# NORTH TEXAS MUNICIPAL WATER DISTRICT

## LAKE SIDE INTERCEPTOR REPLACEMENT

PROJECT NO. SRWWPCF 07-1(102)

### CONFORMED SET

**NORTH TEXAS MUNICIPAL WATER DISTRICT**  
 LAKESIDE INTERCEPTOR REPLACEMENT  
 PLAN AND PROFILE  
 STA. 9+00 TO STA. 14+00

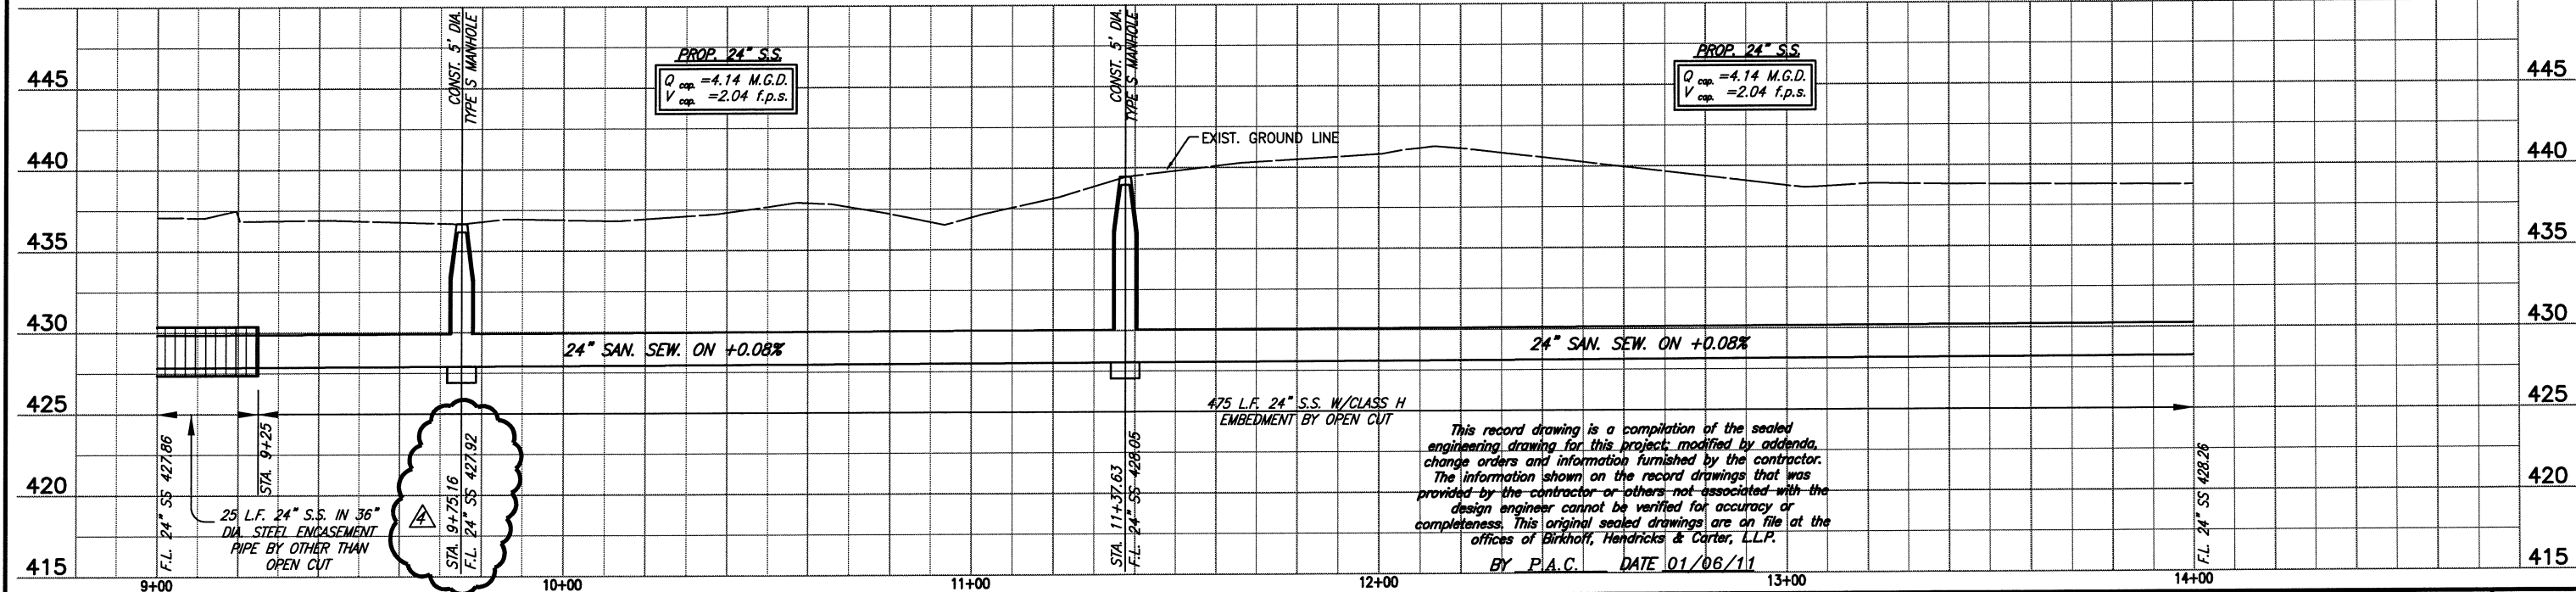
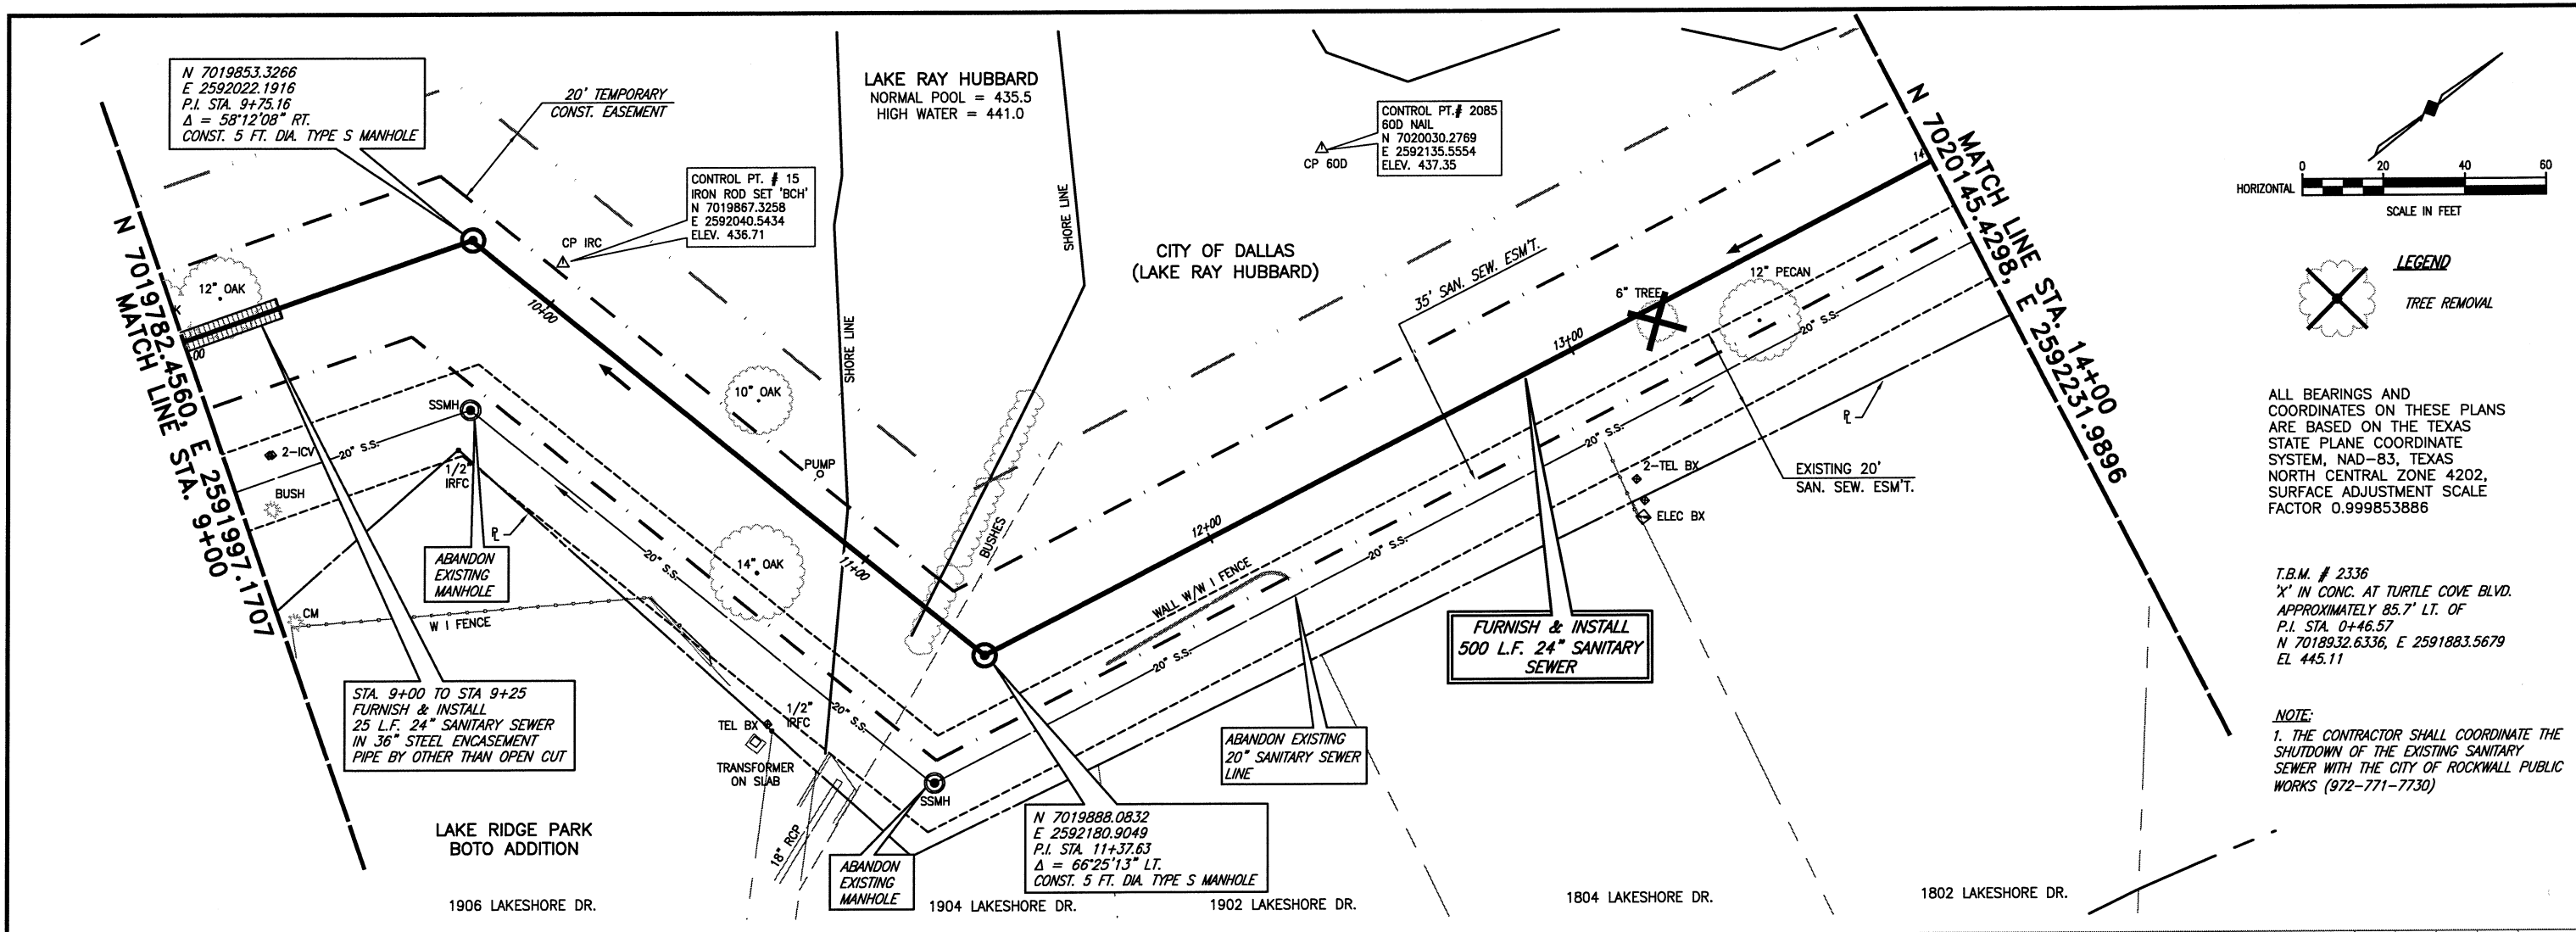
CHANGE ORDER NO.1 2/12/09 - REVISED BORE LOCATIONS & ENCASEMENT
FIELD CHANGE NO.4 6/29/09 - REVISED VERTICAL ALIGNMENT

**PLAN AND PROFILE**  
 STA. 14+00 TO STA. 19+00

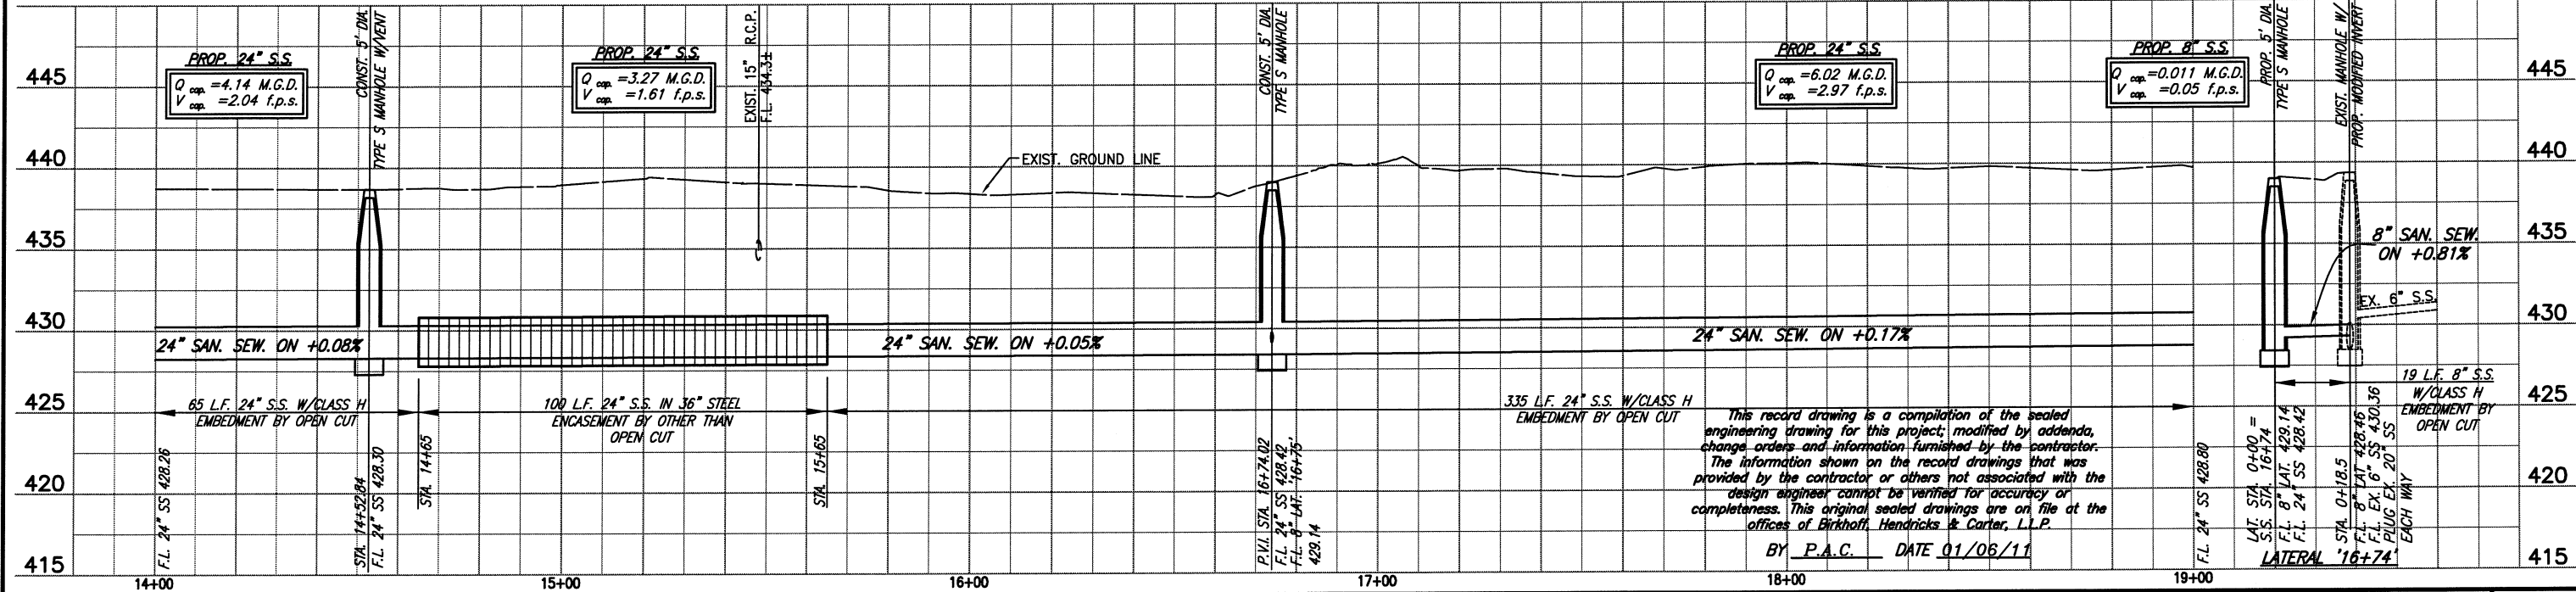
CHANGE ORDER NO.1	2/12/09	REVISED BORE LOCATIONS & ENCASEMENT
FIELD CHANGE NO.4	6/29/09	REVISED VERTICAL ALIGNMENT
INSTALLED BY OTHERS	8/20/2010

<b>NORTH TEXAS MUNICIPAL WATER DISTRICT</b>		BHC PROJECT NO. 2007-104	SHEET NO. 8
LAKESIDE INTERCEPTOR REPLACEMENT		June, 2009	
<b>PLAN AND PROFILE</b> STA. 19+00 TO STA. 24+00

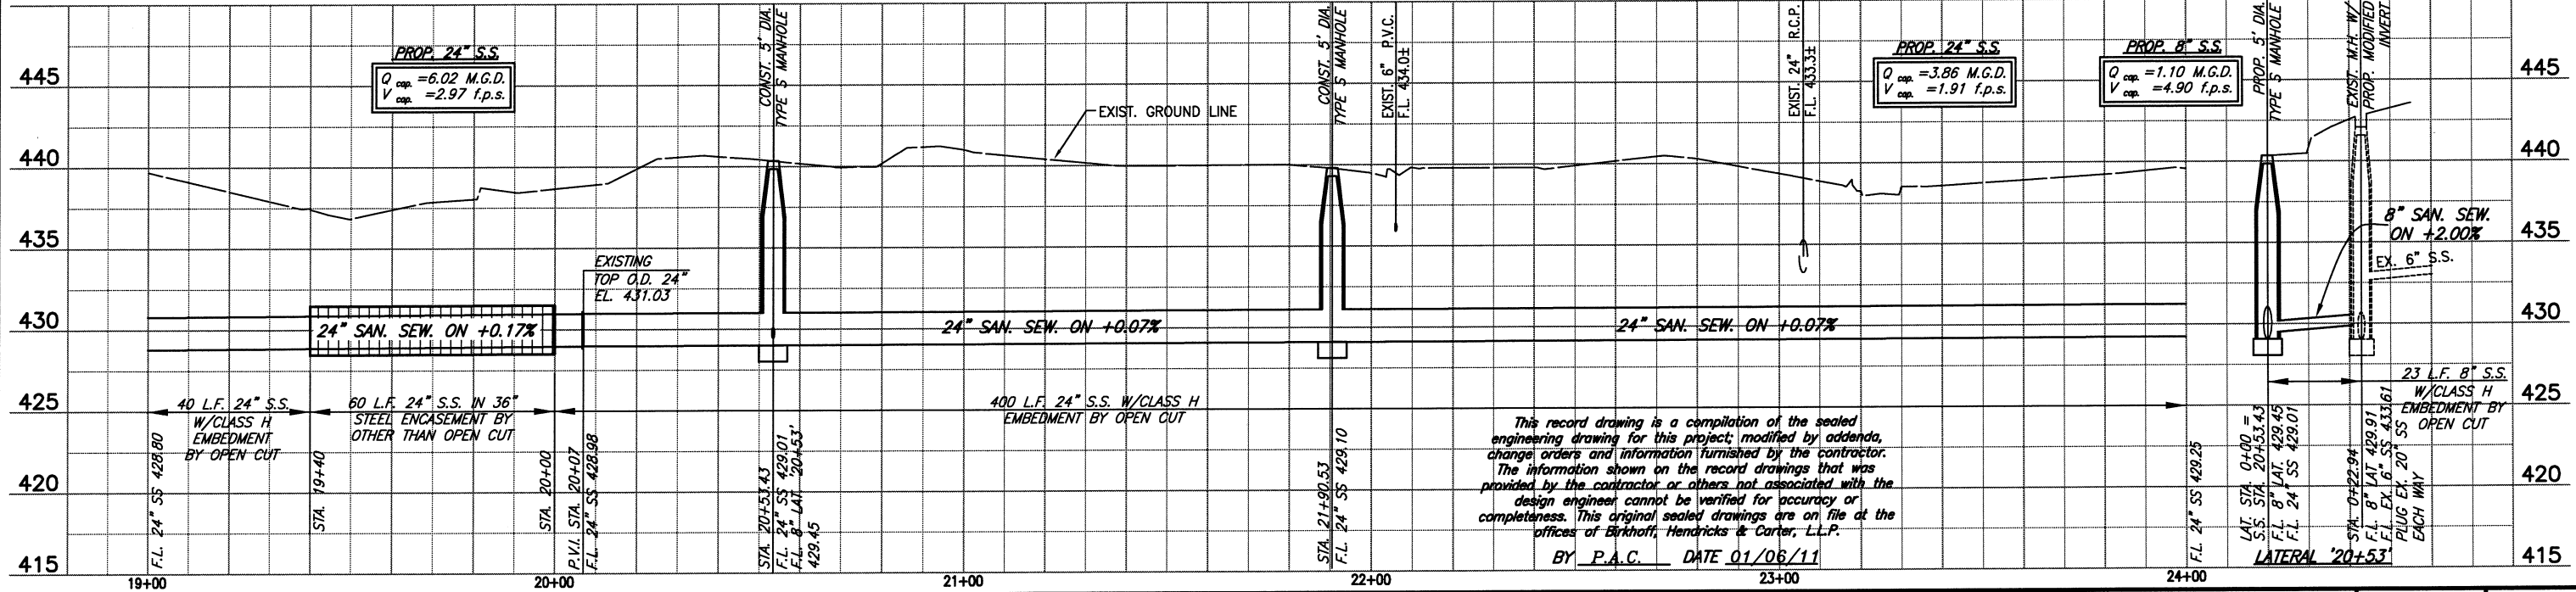
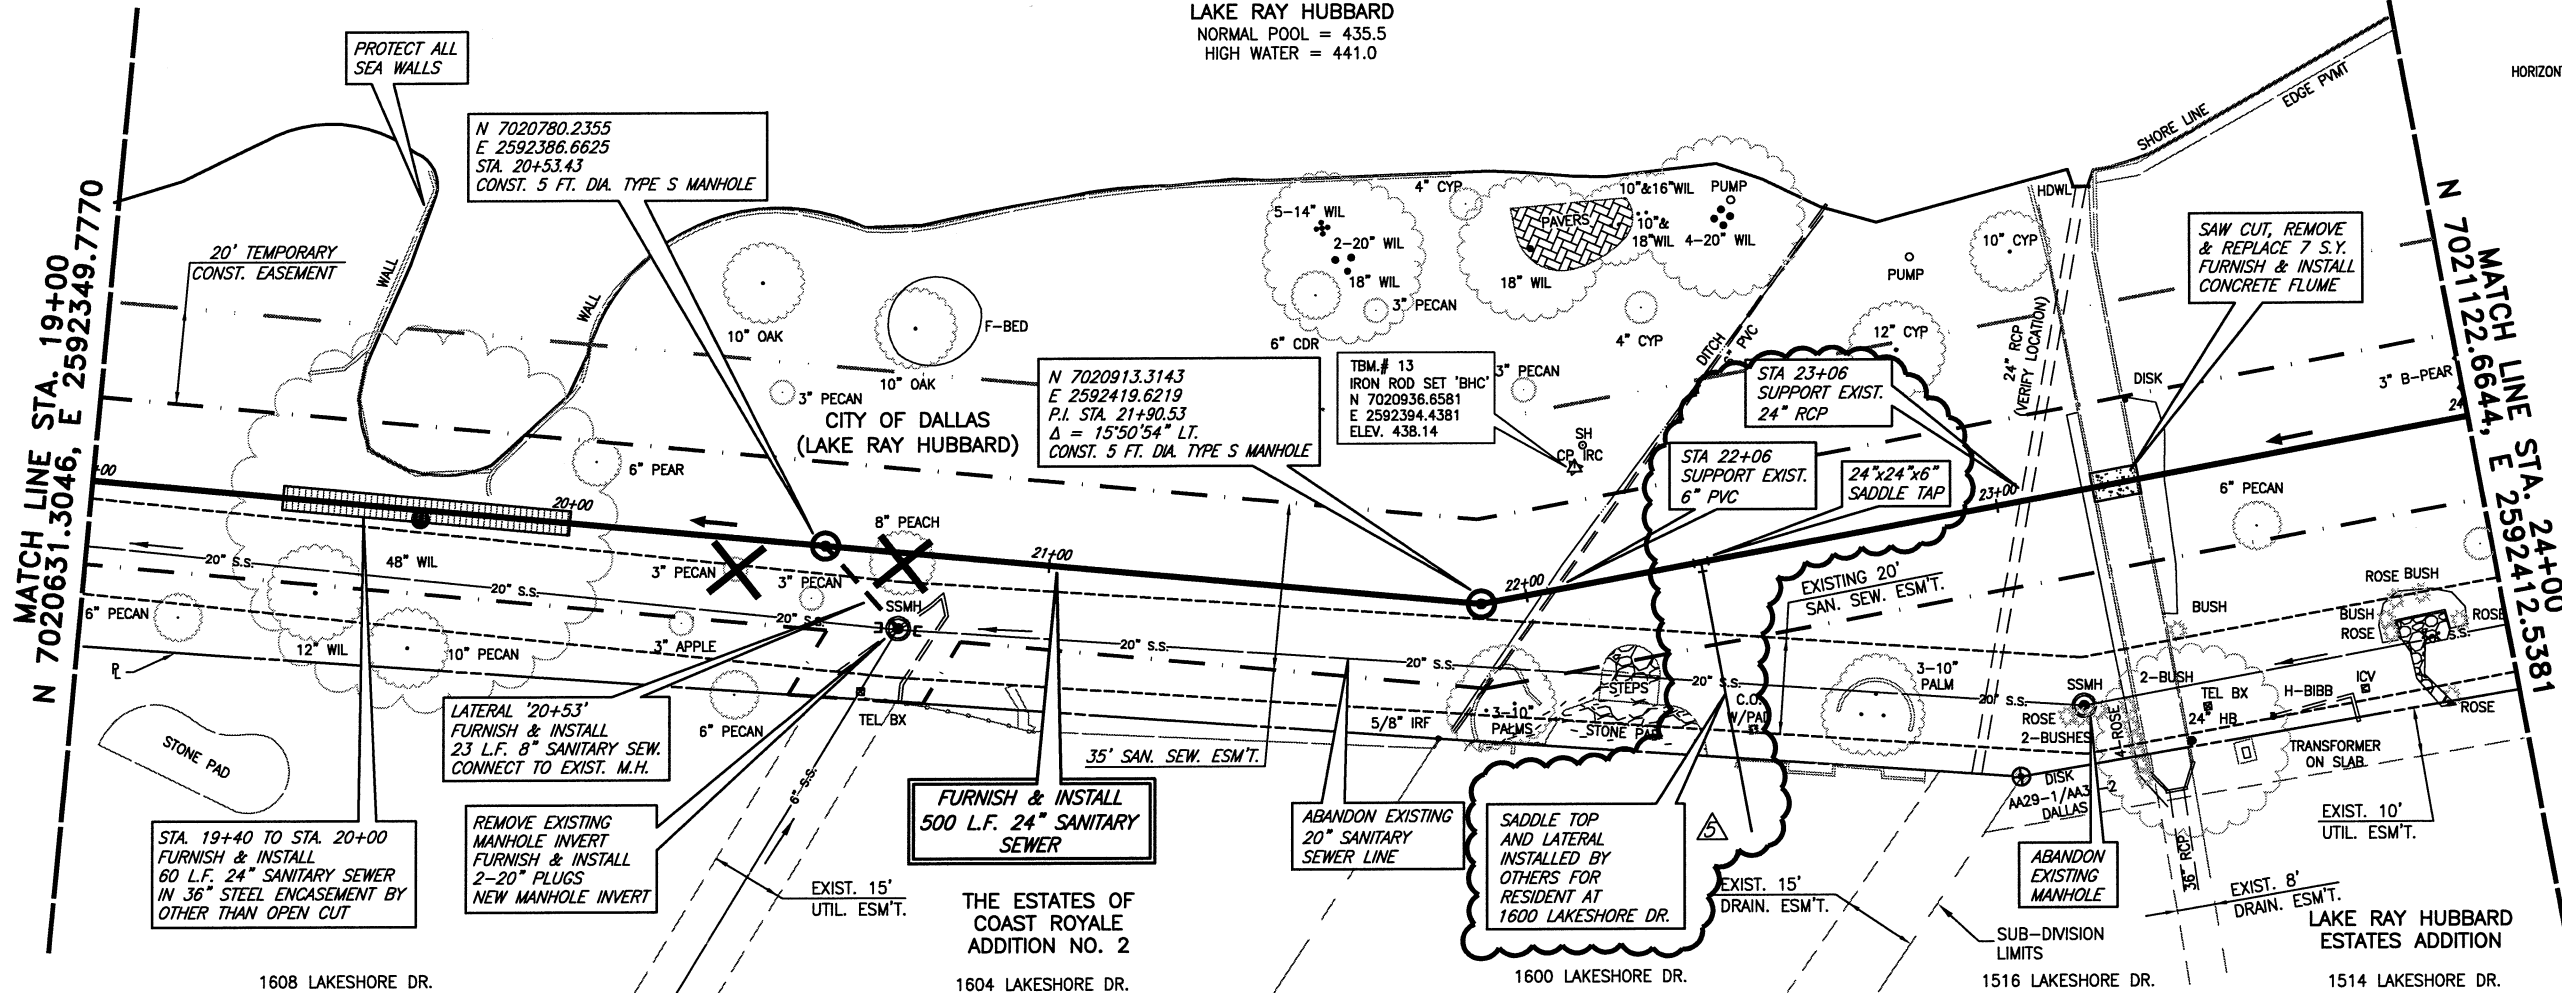
- △ FIELD CHANGE NO.2 2/12/09 - REVISED TREE REMOVAL LOCATIONS
- ① CHANGE ORDER NO.1 2/12/09 - REVISED BORE LOCATIONS & ENCASEMENT
- △ FIELD CHANGE NO.4 6/29/09 - REVISED VERTICAL ALIGNMENT
- △ FIELD CHANGE NO.5 INSTALLED BY OTHERS 11/13/09
